RJER / RISHIRI

STANDARD DEPARTURE CHART-INSTRUMENT

RISHIRI REVERSAL TWO DEPARTURE

VOR A

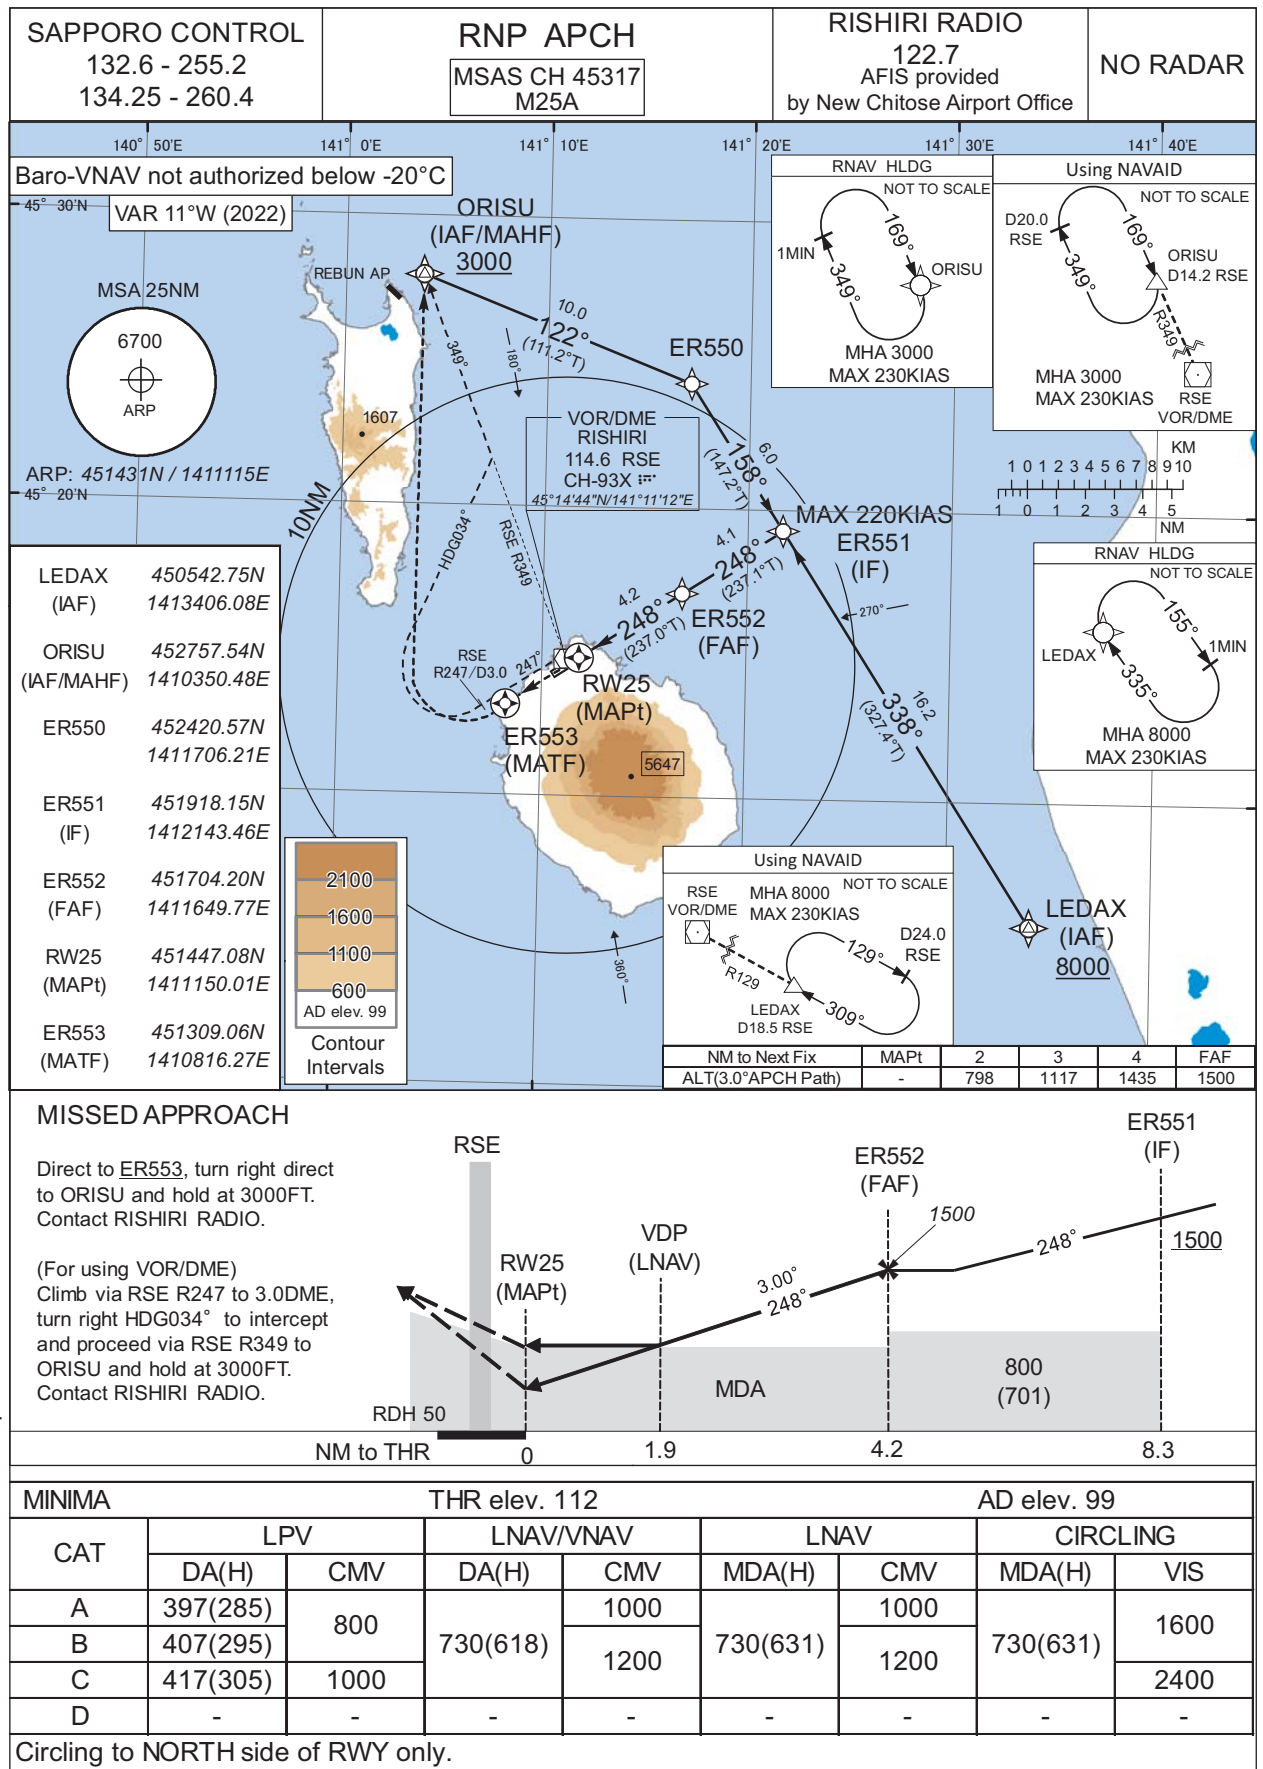
CHANGE : Call sign(REMOTE→RADIO). AFIS unit added.

Minimum Vectoring Altitude CHART

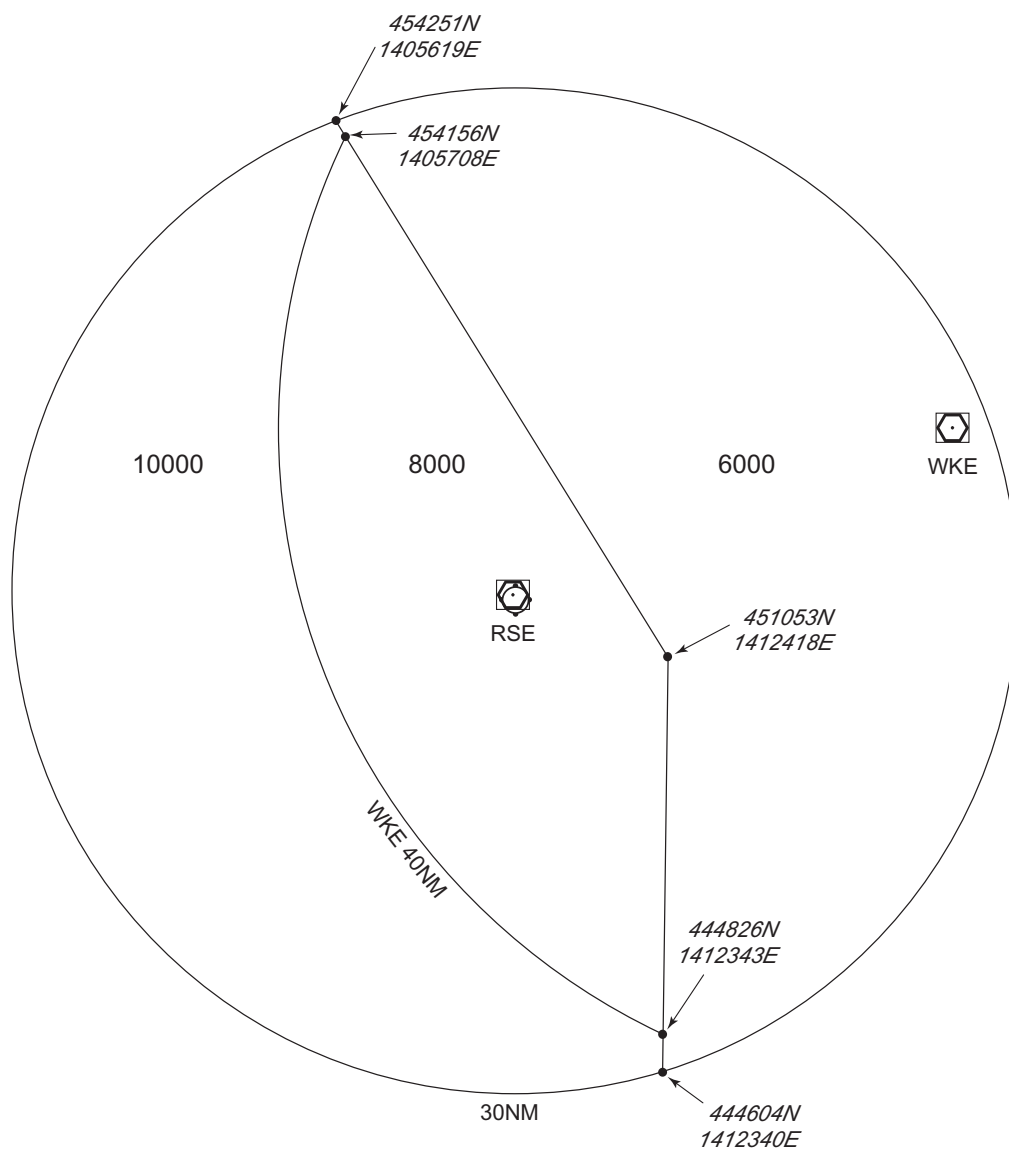
CHANGE : Description of VAR.
